Proposal Request

AWSOM

Proposal Request Number: 120

L4 Maintenance Path

3 L4 Maintenance Path

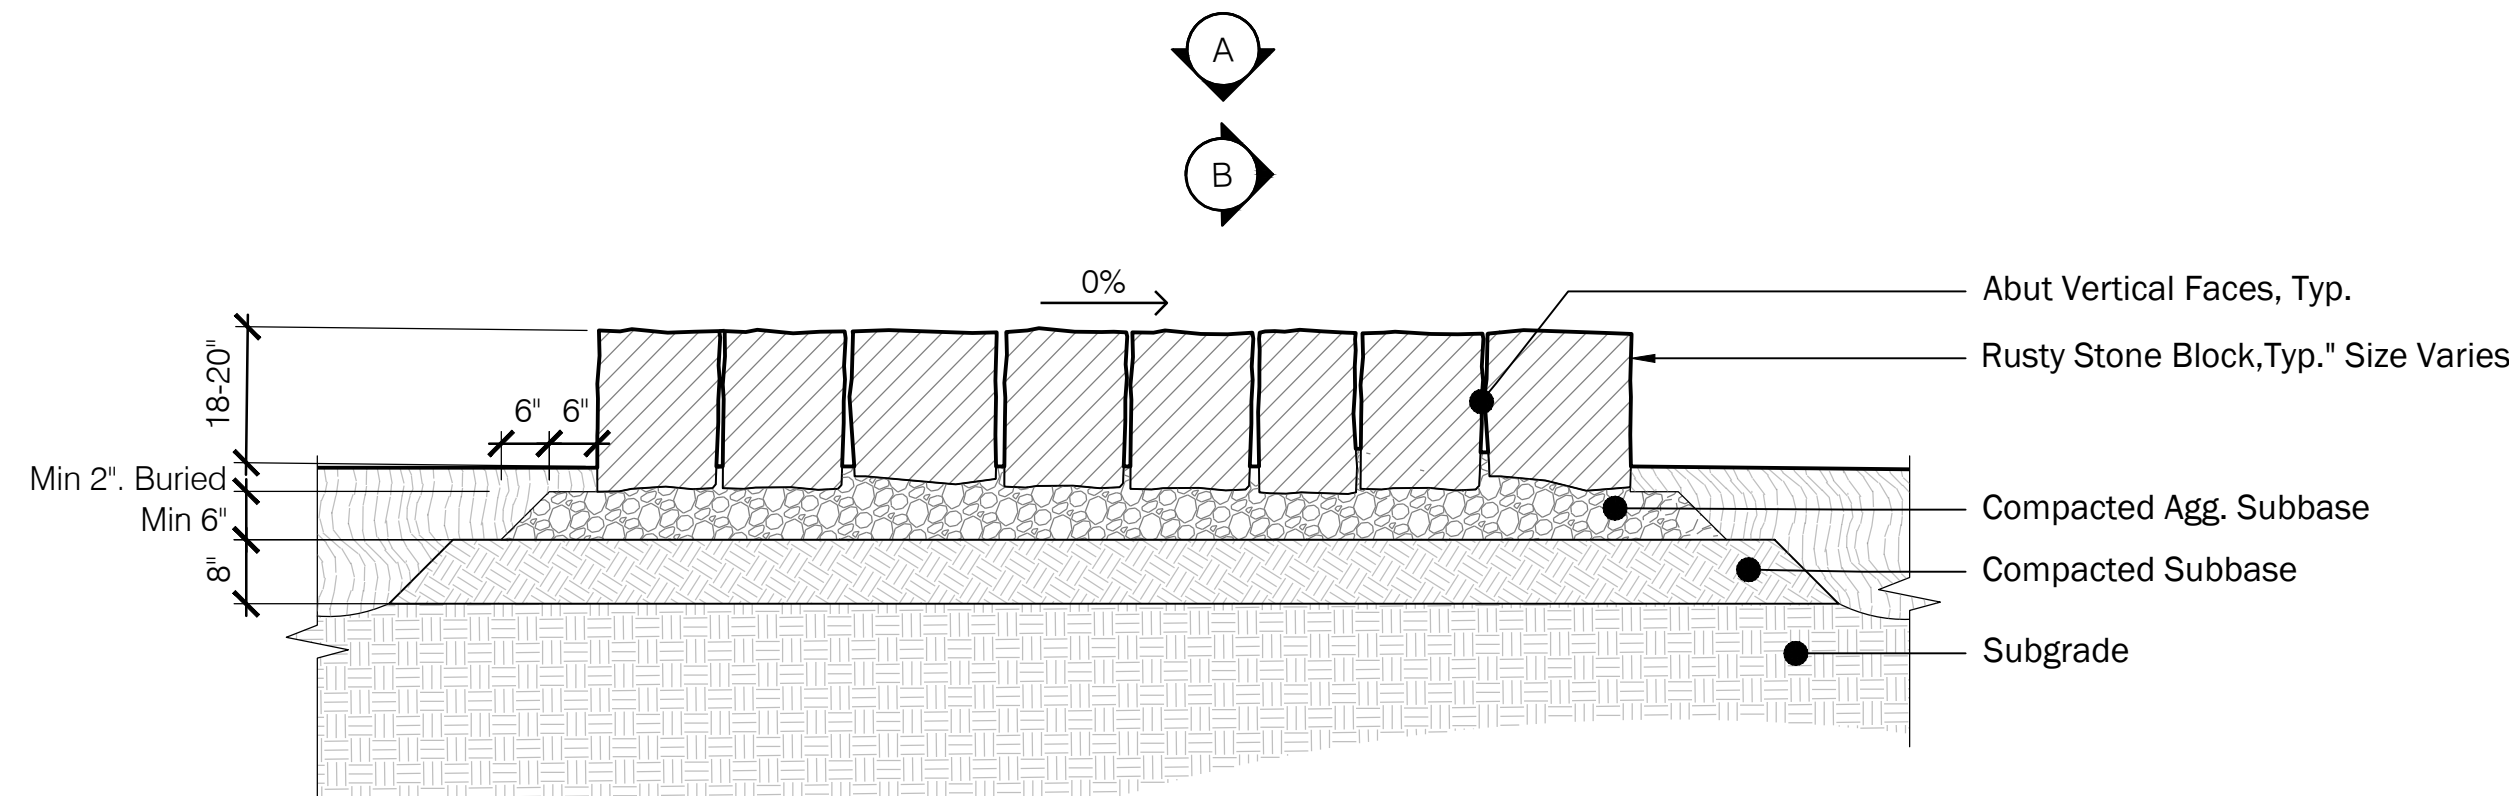
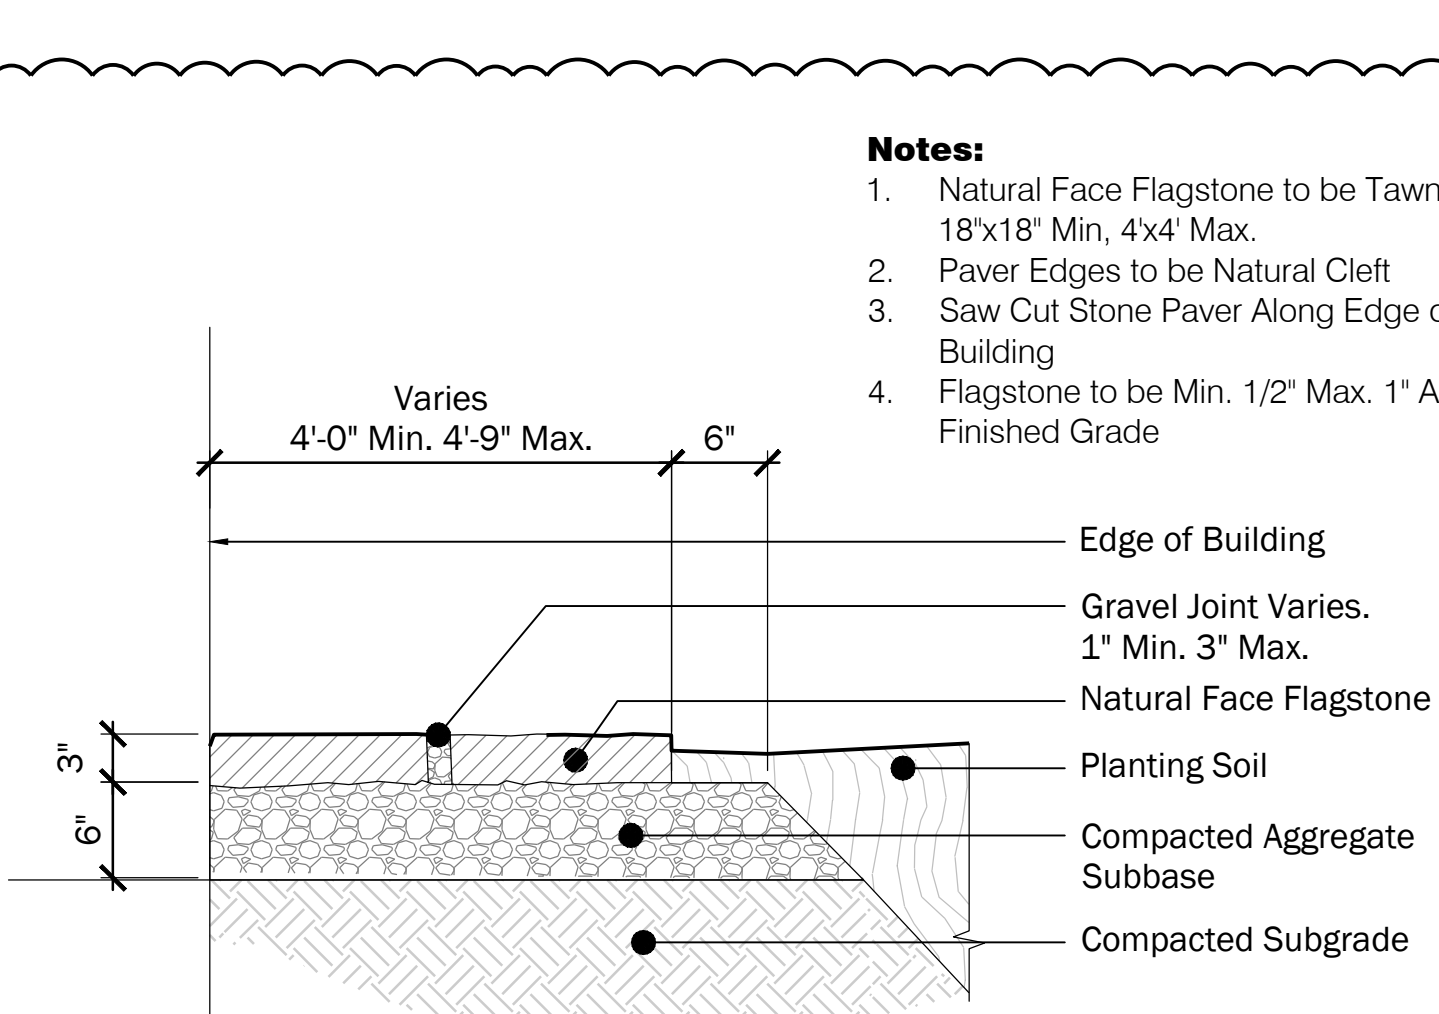
- a) Refer to Revised Sheet **L000B**, with original issue date 10.21.2024 and revised date 04.03.2025.
 - Updated sheet issuance for PR 120.
- b) Refer to Revised Sheet **L105**, with original issue date 03.13.2023 and revised date 04.03.2025.
 - Added L4 Maintenance Path.
 - Added (2) Segments of Plant Rail.
 - Added note "Signage by Owner."
- c) Refer to Revised Sheet **L205**, with original issue date 03.13.2023 and revised date 04.03.2025.
 - Added layout for L4 Maintenance Path.
 - Added layout for (3) Segments of Plant Rail.
- d) Refer to Revised Sheet **L305**, with original issue date 03.13.2023 and revised date 04.03.2025.
 - Revised grading to accommodate L4 Maintenance Path.
- e) Refer to Revised Sheet **L916**, with original issue date 03.13.2023 and revised date 04.03.2025.
 - Added L4 Maintenance Path detail.

- Notes:**
1. Natural Face Flagstone to be Tawny Beige, 18"x18" Min. 4x4 Max.
 2. Paver Edges to be Natural Cleft
 3. Saw Cut Stone Paver Along Edge of Building
 4. Flagstone to be Min. 1/2" Max. 1" Above Finished Grade
